CONTRACT CHANGE ORDER NO. _____
SHEET ____ OF ____

ALTERNATE BARRIER DETAILS - CONNECTION BEFORE LOAD TRANSFER

SAN FRANCISCO OAKLAND BAY BRIDGE
EAST SPAN SEISMIC SAFETY PROJECT
SELF-ANCHORED SUSPENSION BRIDGE
(SUPERSTRUCTURE & TOWER)

BARRIER DETAILS NO. 2C

PLAN-STEEL BARRIER Type 732 Modified for W5 E2
1:10 (See Note 13)

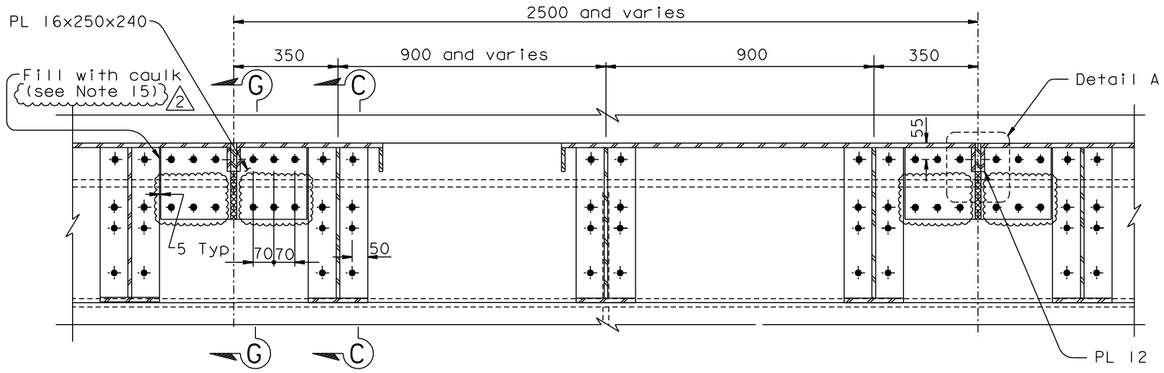
15. At the Contractor's option, a seal weld may be used in lieu of caulk seal between:
    - Base PL 25 & PL 12
    - Base PL 25 & PL 16
    - PL 16 & PL 12,

subject to review and approval of the Engineer. (2) (1)
16. At the Contractor's option, the PL 8 may be removed provided the caulk with backer rod is extended to the top of steel deck, subject to review and approval of the Engineer. (2)
